Permit to Alter Case Report

Filing Date: October 18, 2012
Case No.: **2012.1326H**
Project Address: **1 Kearny Street**
Category: Category I (Significant)
Conservation District: Kearny-Market-Mason-Sutter
Zoning: C-3-O (Downtown-Office)
80-130-F Height and Bulk District
Block/Lot: 0312/031
Applicant: Tony Sanchez Corea
301 Junipero Serra Boulevard, Suite 270
San Francisco, CA 94127
Staff Contact: Gretchen Hilyard - (415) 575-9109
gretchen.hilyard@sfgov.org
Reviewed By: Tim Frye - (415) 558-6625
tim.frye@sfgov.org

Historic Preservation Commission Motion No. XXXX Permit to Alter MAJOR ALTERATION

Shop Drawings - Window Elevation

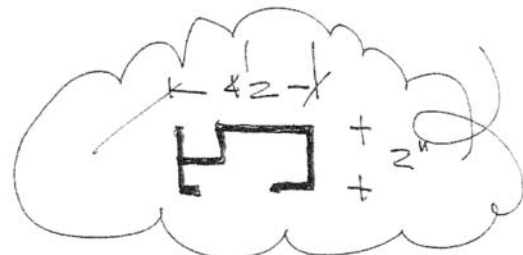
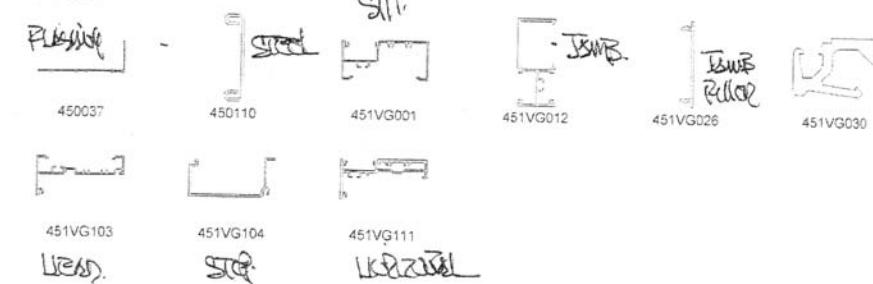
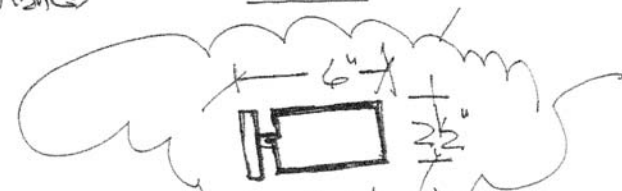
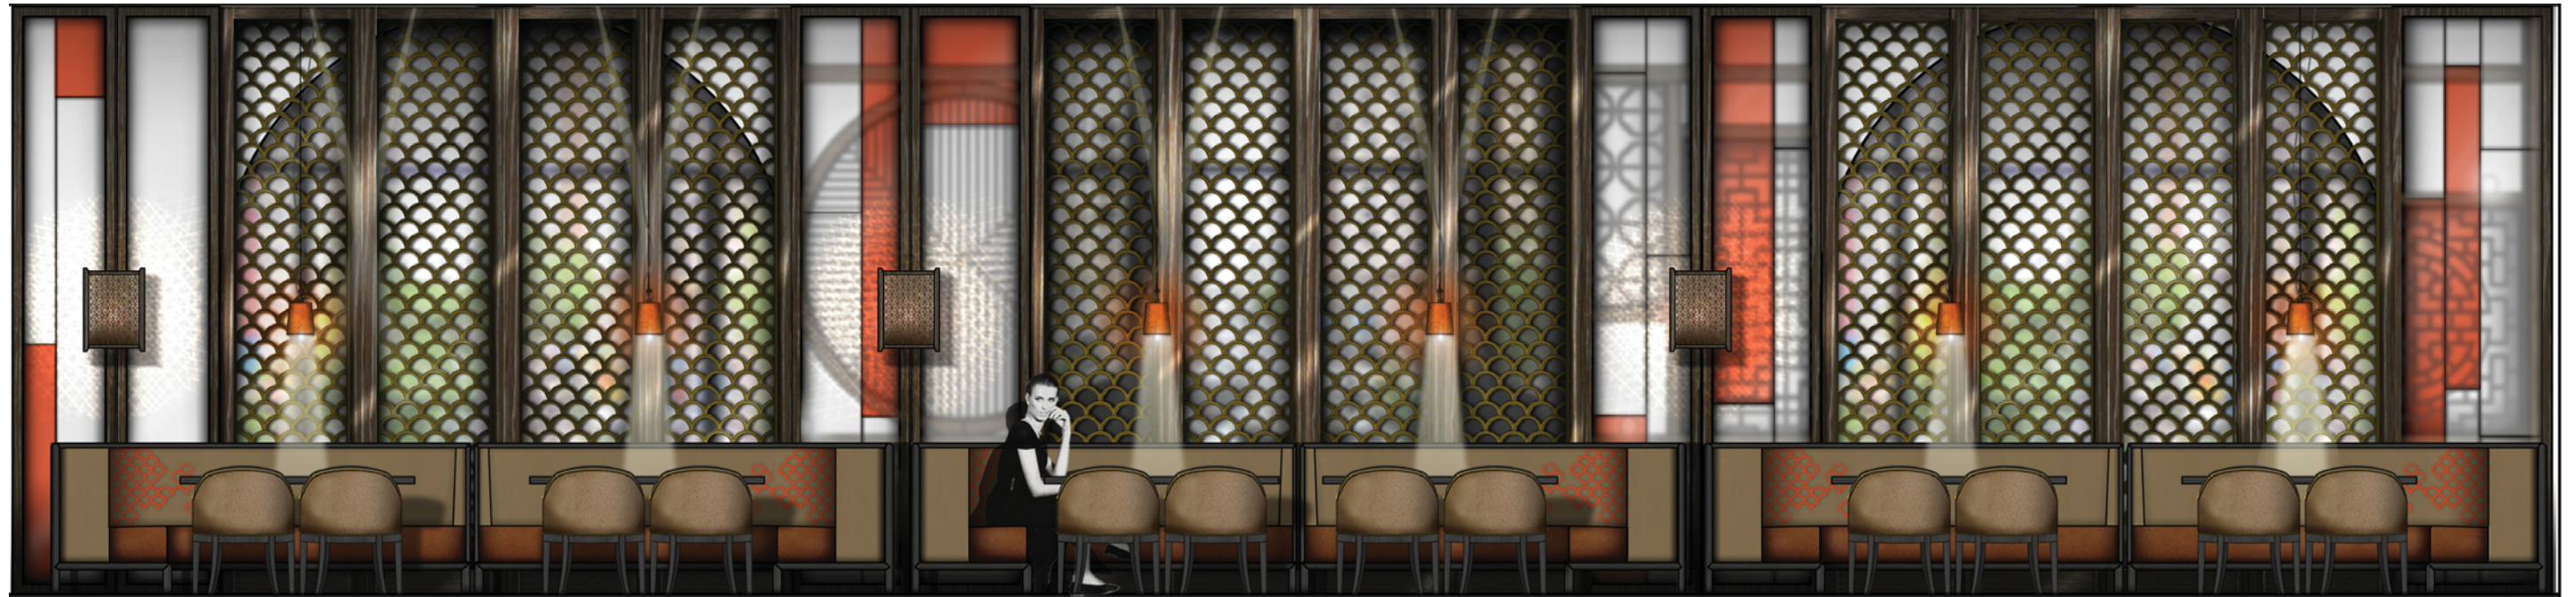
provide sample for comparison to existing finish

coordinate with concrete curbs as being fabricated on site.

1. Verify vertical mullions align (visually) with mullions on level below. This is required for Historical Review Board sign off.
2. Sliding door is required for access to exterior balcony.
3. Finish of framing and mullions to match system that was removed (or level below)

Provide sample of Insulated glass for review. Provide cut sheet on glass to verify R/U values and compliance with Title 24 Envelope Calcs.
